REVISIONS
REVISION #1: 8.8.2022

ELEVATIONS
BUILDING 'A'

A-2.0.1

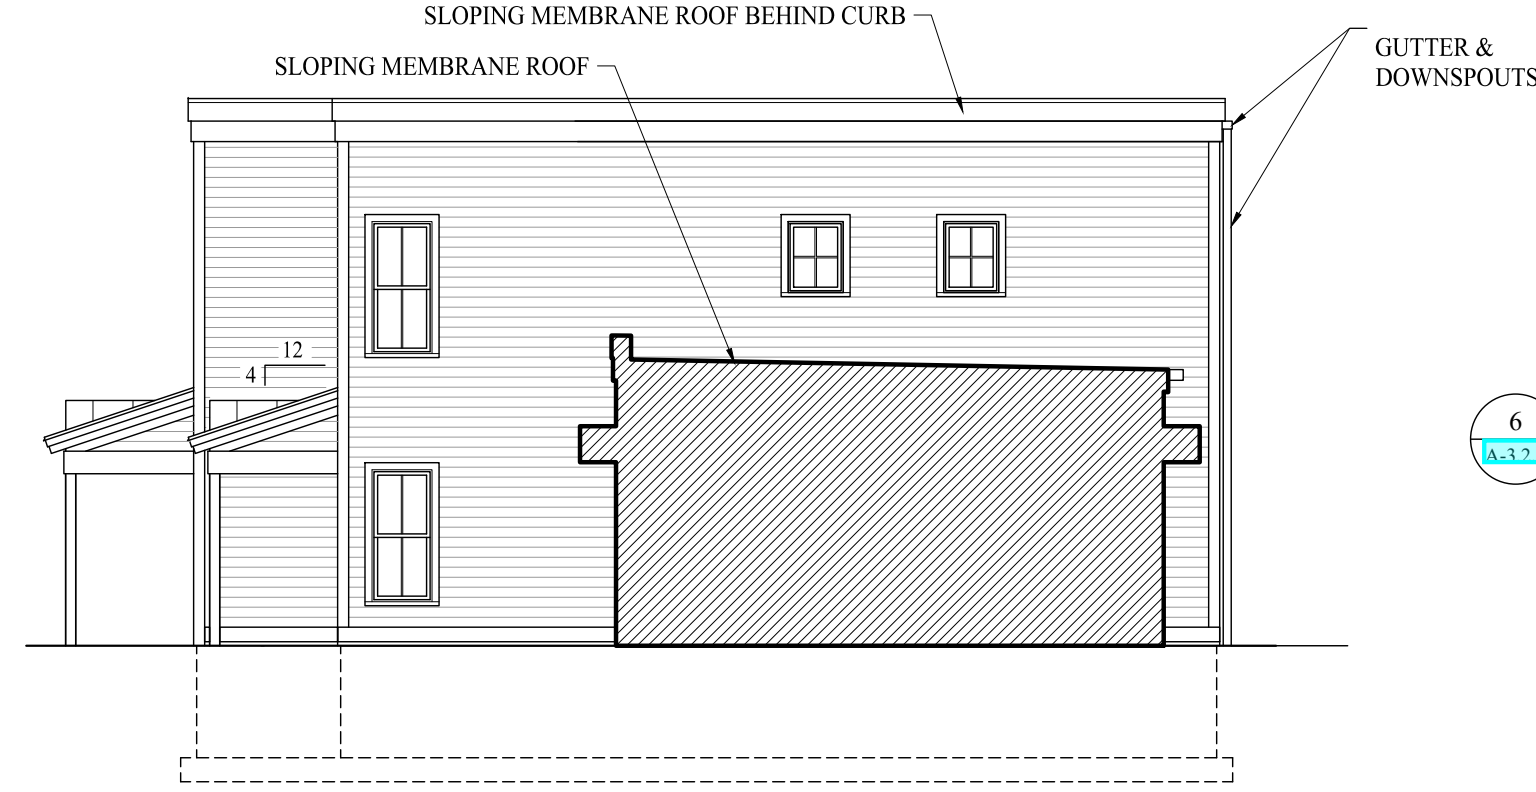
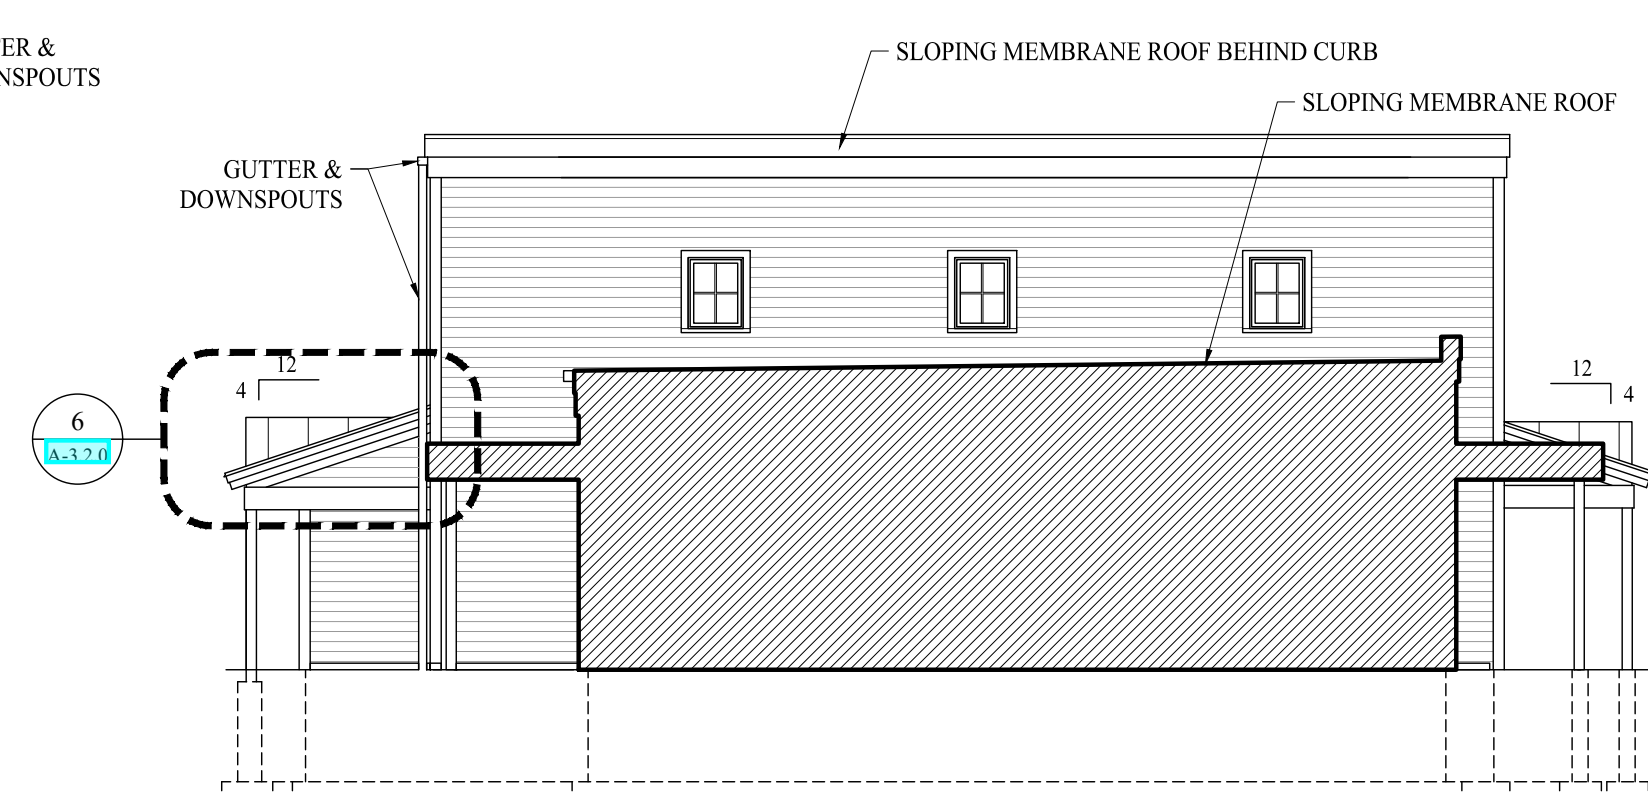
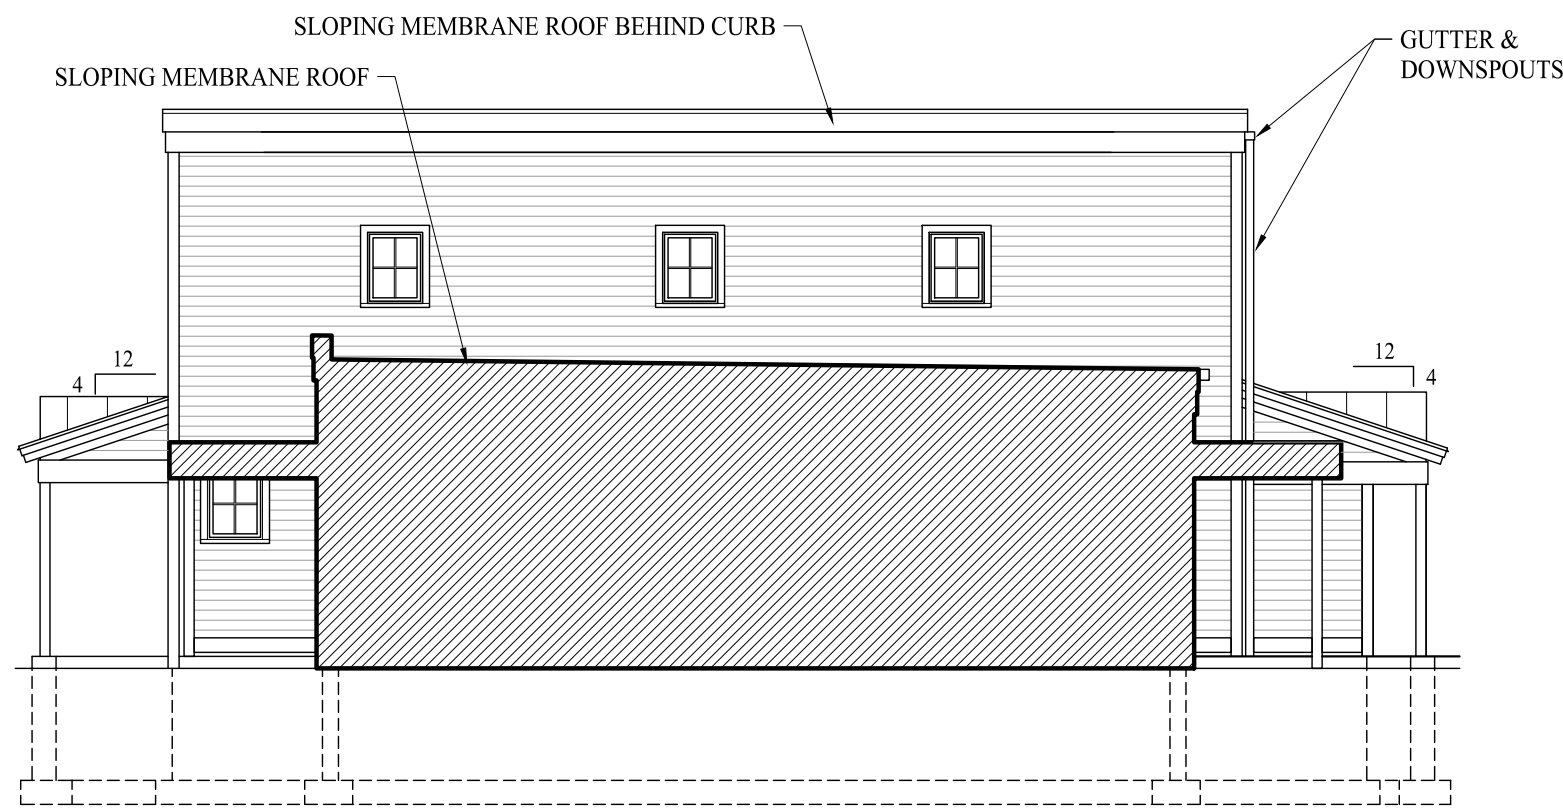
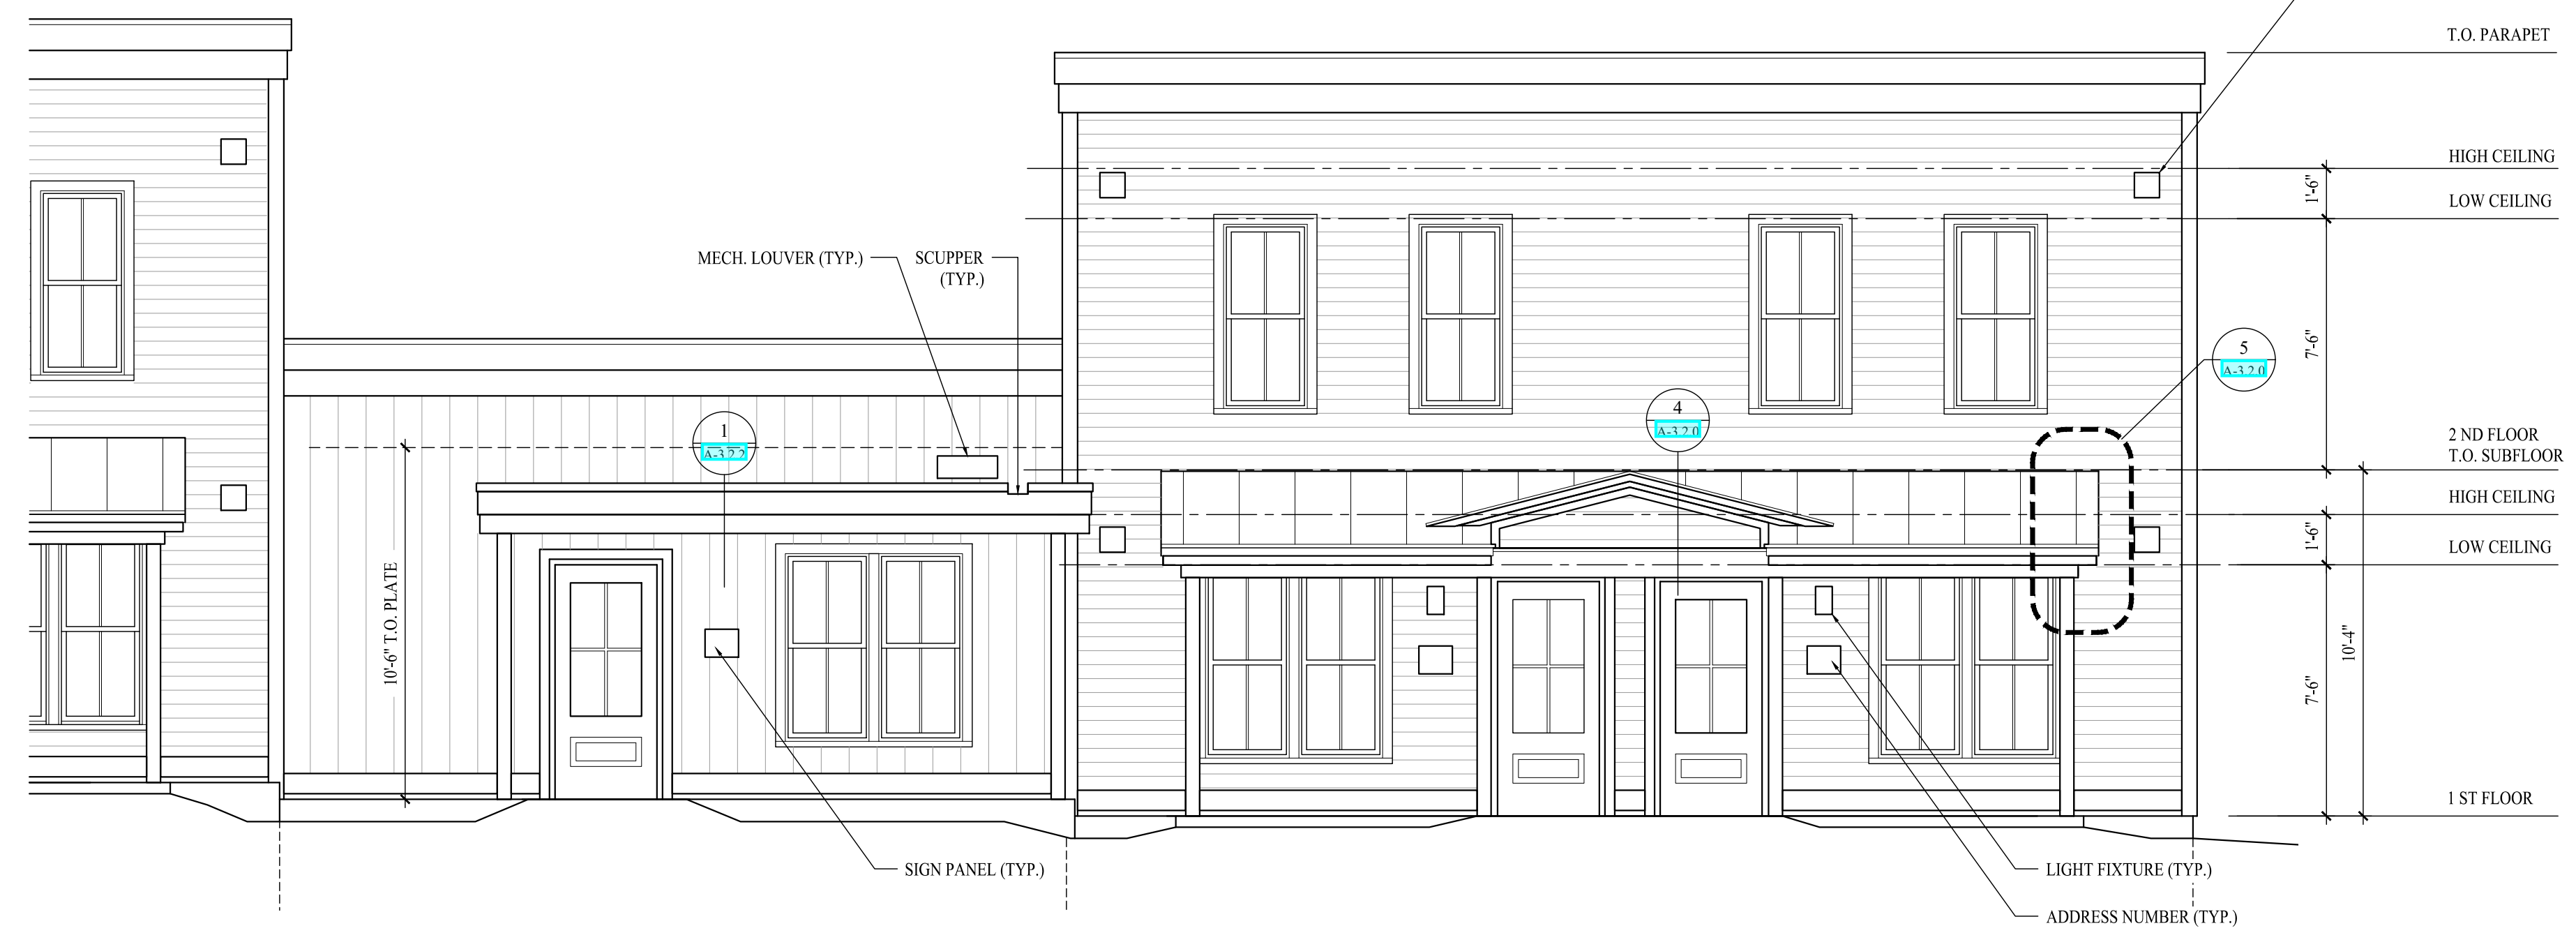
Accepted Value Engineering Options
 1. VE #1a - Consider Vinyl Siding ILO Fiber Cement. Exterior trim changes to Hardie Fiber Cement ILO Boral
 2. VE #2e - Consider Paradigm windows (U value 0.27) ILO Marvin
